Gables Station

COMPREHENSIVE PLAN MAP AMENDMENT
ZONING MAP AMENDMENT
ZONING CODE TEXT AMENDMENT
PLANNED AREA DEVELOPMENT
MIXED USE SITE PLAN

215 AND 251 S. DIXIE HIGHWAY
CITY COMMISSION 2ND READING
JULY 26, 2016

#2: FPL POWERLINES

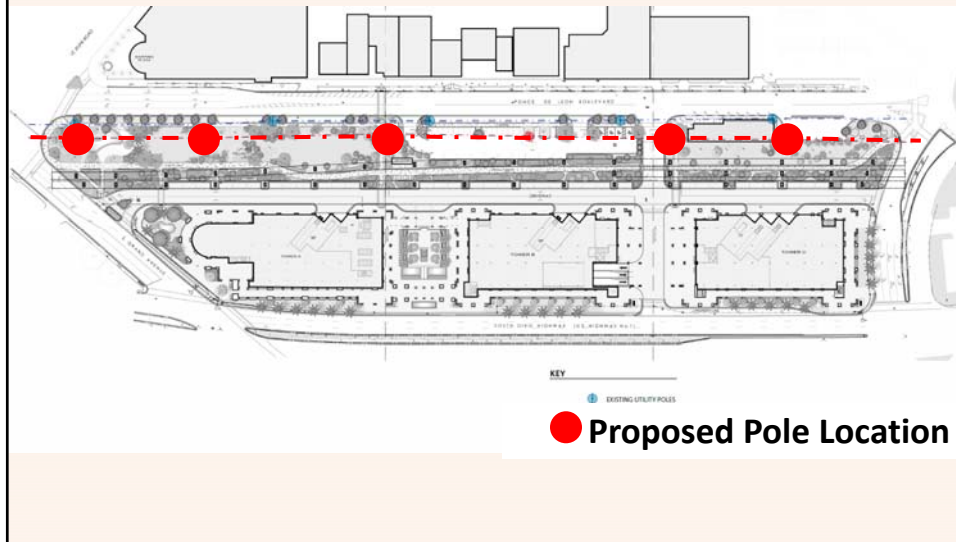
1. Reduce building height while maintaining the same percentage of open space.
2. Show FPL powerline locations in drawings of the Underline.
3. Finalize the trolley contribution proposal.
4. Confirm the timing of the Underline improvements.
5. Update the Traffic Impact Study.
6. Provide the Art in Public Places concept.
7. Update site plan to include more landscaping at the ground level.
